**SUPPLEMENTAL CLOSURE PLAN REPORT
SULLIVAN LANDFILL
SULLIVAN, MISSOURI**

SUPPLEMENTAL CLOSURE PLAN REPORT
SULLIVAN LANDFILL

2.0 RESPONSE TO MDNR COMMENTS OF FEBRUARY 25, 1993

FIGURE 8
SETTLEMENT MONITORING LOCATIONS
SULLIVAN, MO. LANDFILL

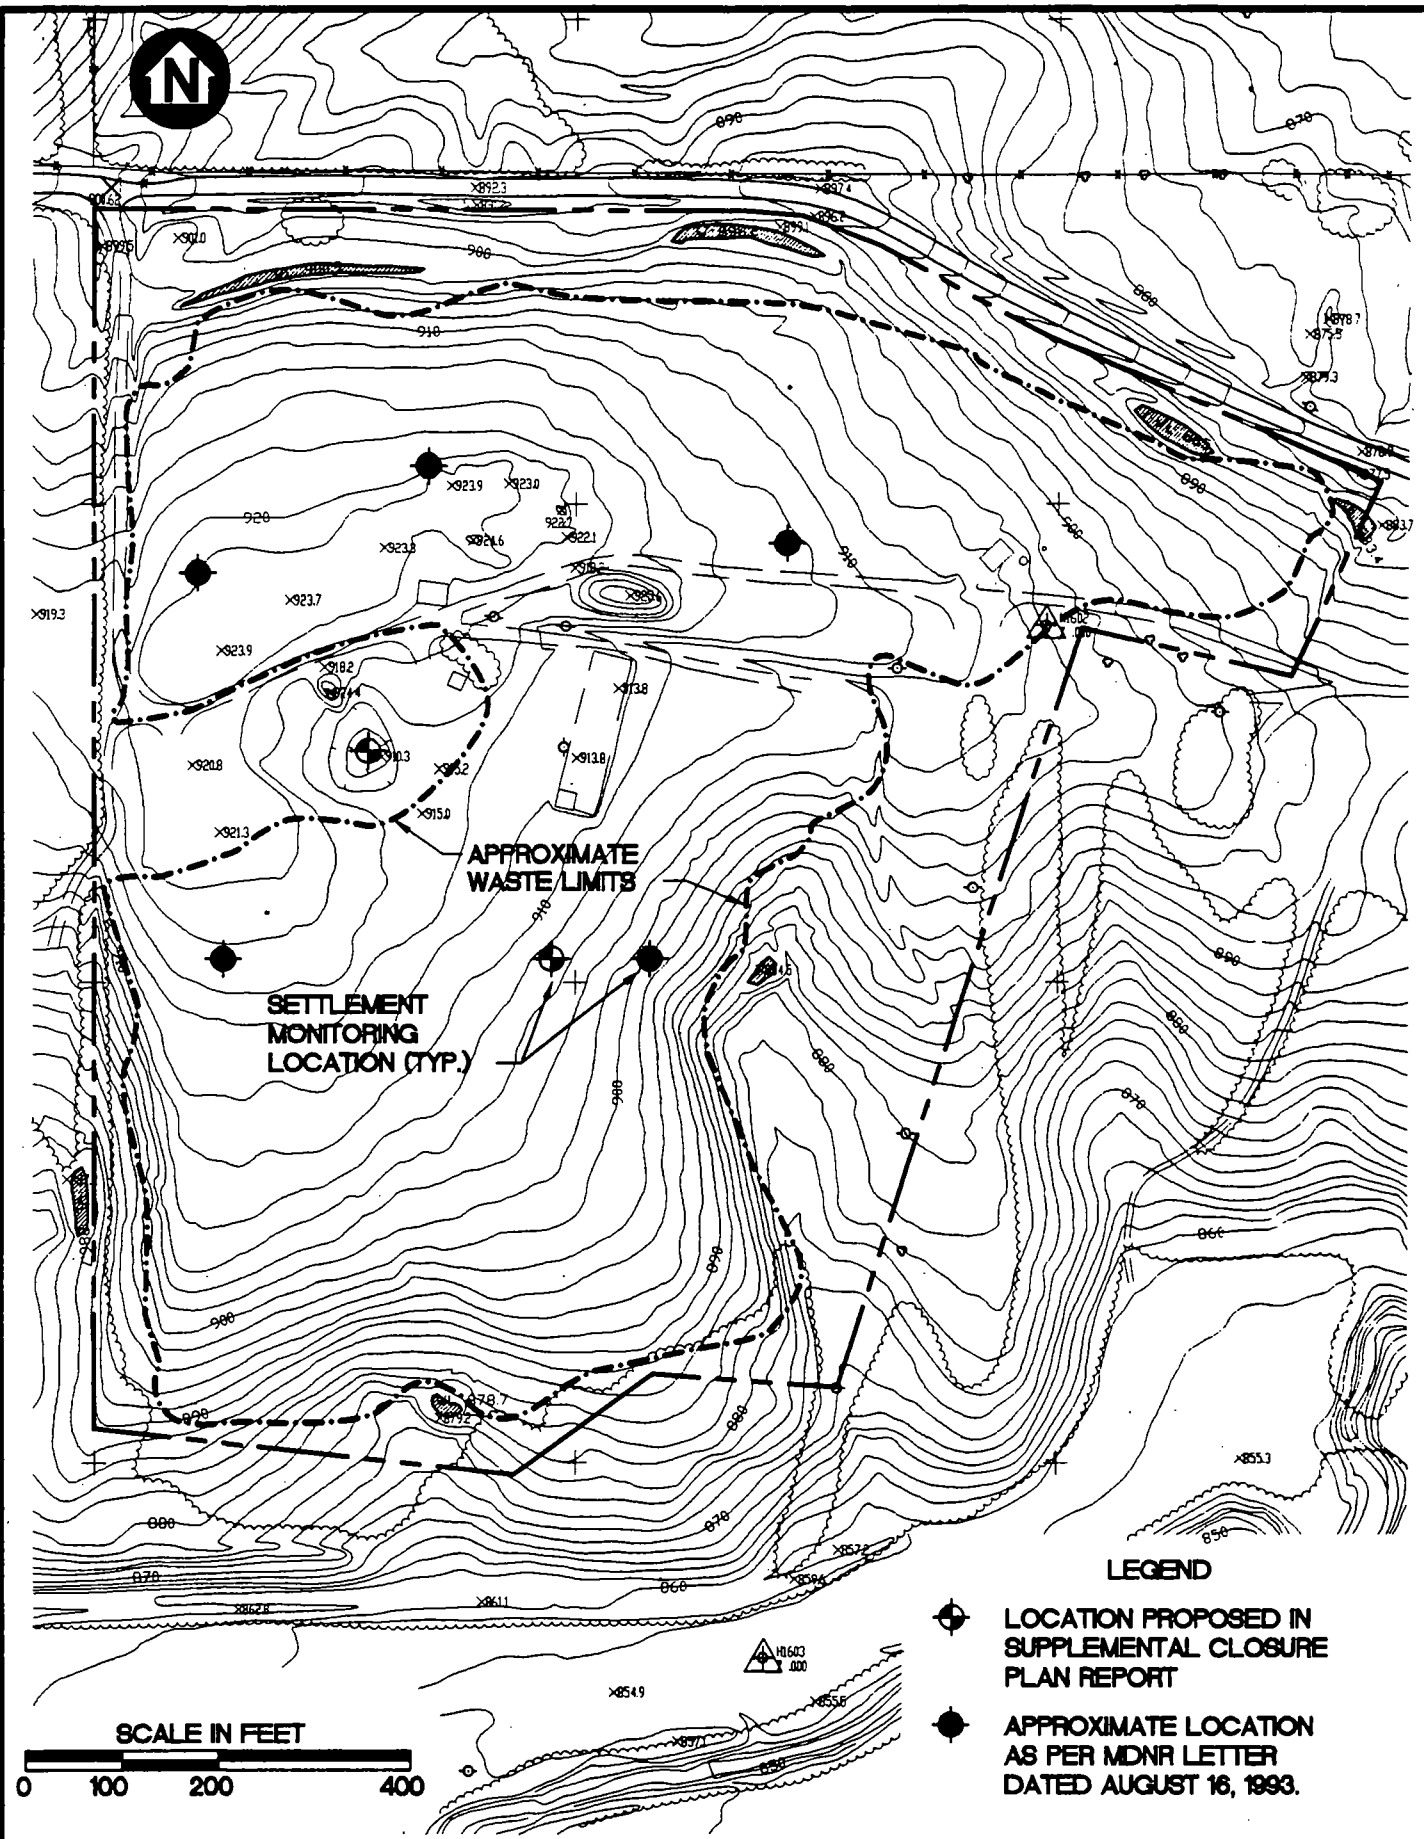
MDNR requested that more information be provided relative to landfill cap settlement monitoring during the post-closure monitoring and maintenance period.

Details of the proposed settlement markers and placement locations are shown in Figure 7 and 8, respectively. Settlement monitoring will be performed quarterly during the first year of post closure, semiannually for the following two years, and annually through the fifth post-construction year. Based on results to that point, recommendations will be made for frequency of future continued monitoring, if required.

FIGURE 1
SETTLEMENT MONITORING LOCATIONS
SULLIVAN, MO. LANDFILL

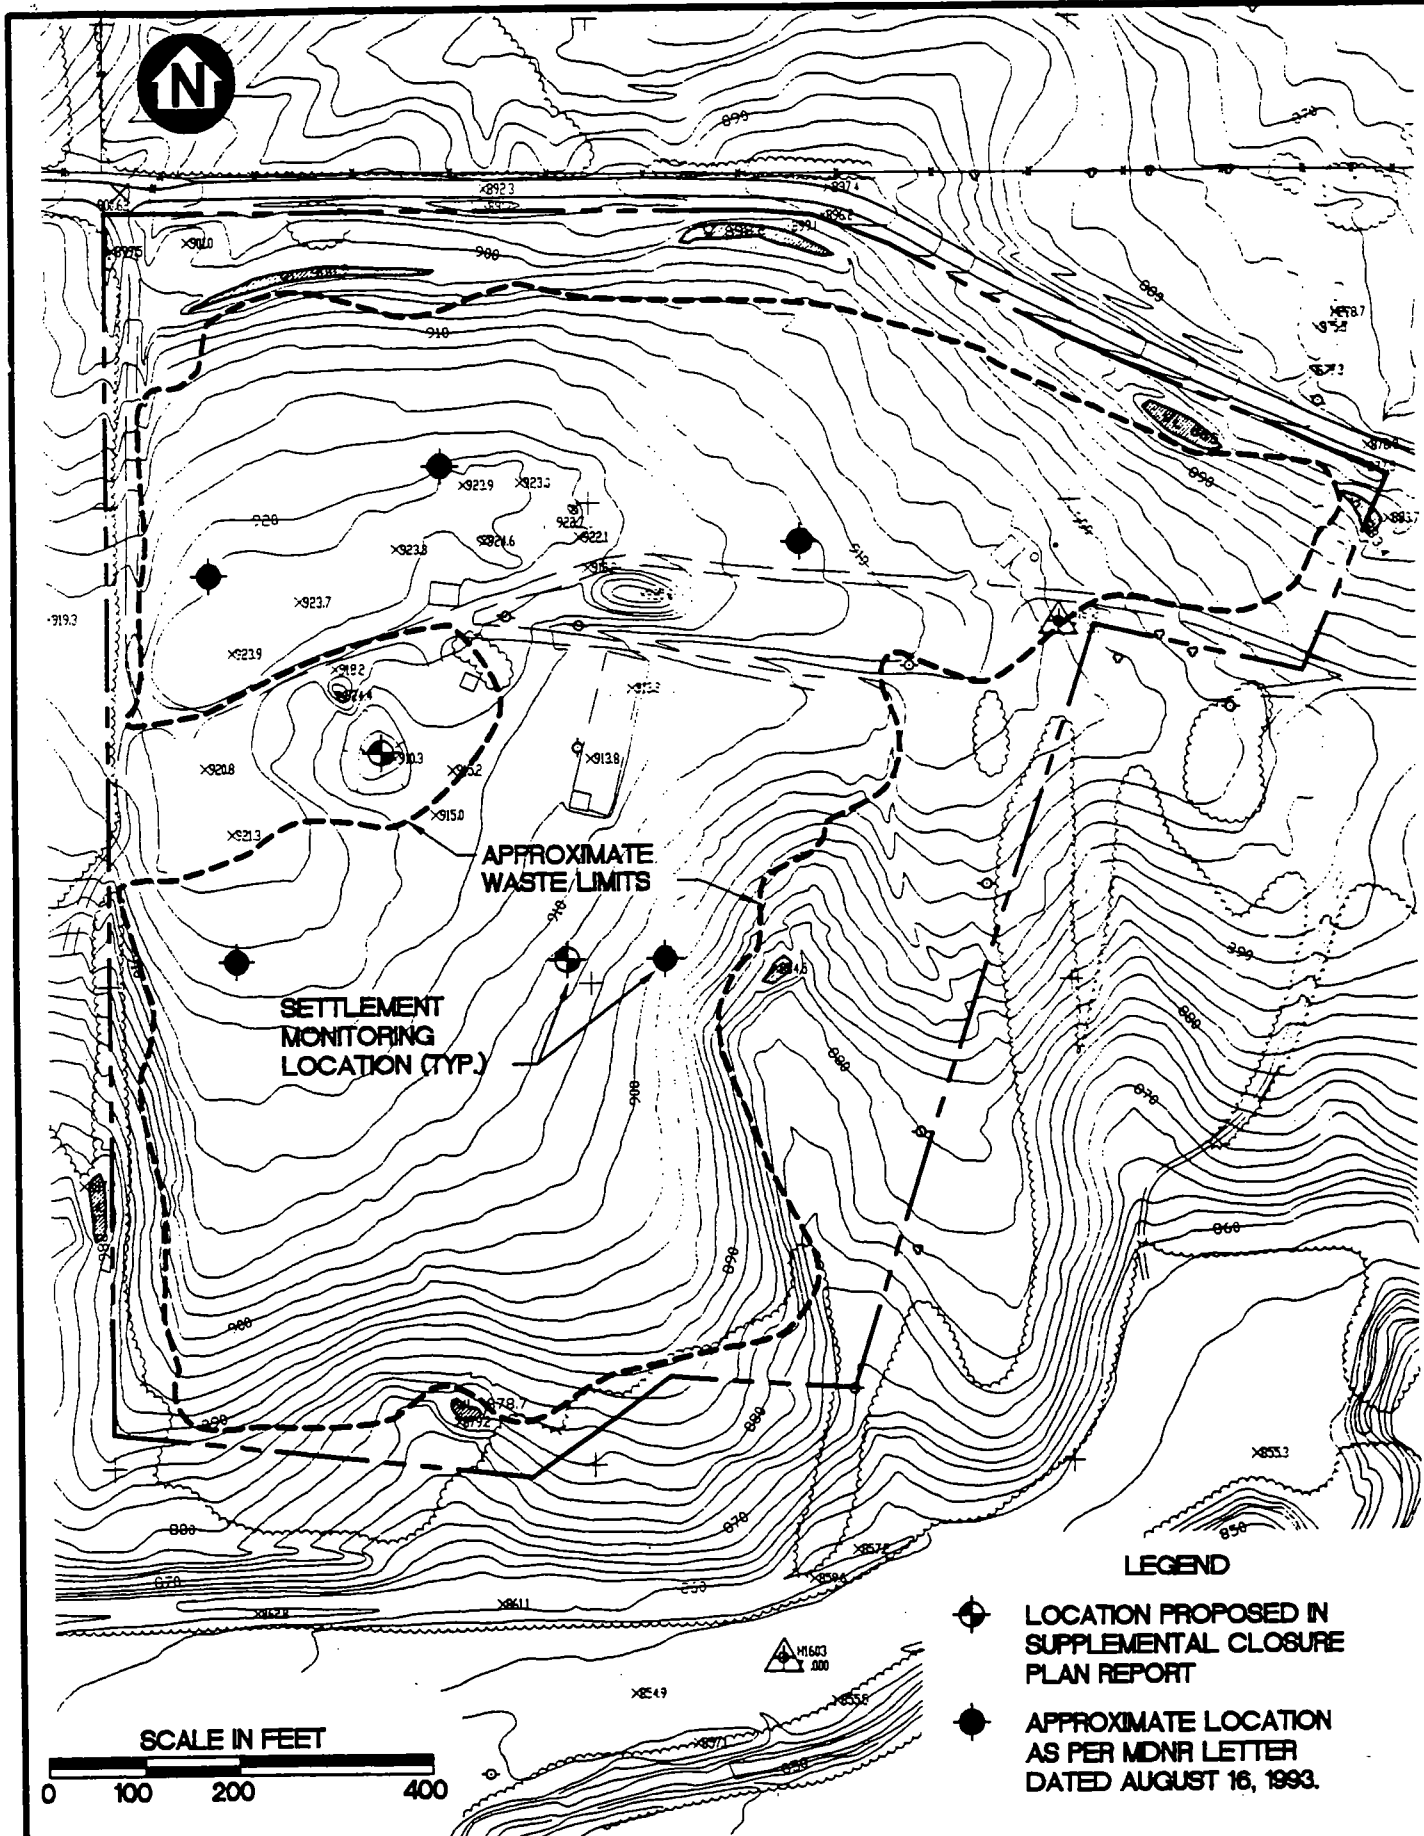
Your letter dated August 16, 1993 acknowledged that there were four outstanding issues to be resolved before Missouri Department of Natural Resources (MDNR) could complete approval of the Site Investigation and Remedial Alternatives (SIRA) Study and the Closure Plan for the Sullivan Landfill closure. The Sullivan Landfill PRP Group agrees to modify the proposed Closure Plan approach to fully address the four issues identified in your letter. On this basis we request your formal approval of the SIRA Investigation Report and the Closure Plan so that we may proceed expeditiously with the closure design and planning for the construction activities.

4. Additional settlement markers will be added to the landfill settlement monitoring program as follows: Settlement markers will be installed at the top of the slope on the west side; on the east side and the west side of the top of the slope at the south end of the "ravine fill" area; and, two at the top of the slope along the north perimeter of the trench fill area. As indicated in your letter, our initially proposed northernmost marker is substituted with these. General locations for proposed settlement markers are shown in the attached figure. Settlement surveys will be run quarterly during the first year, semiannually for the following two years, and annually through the fifth post-construction year. Based on results to that point, recommendations will be made for frequency of future continued monitoring, if required.
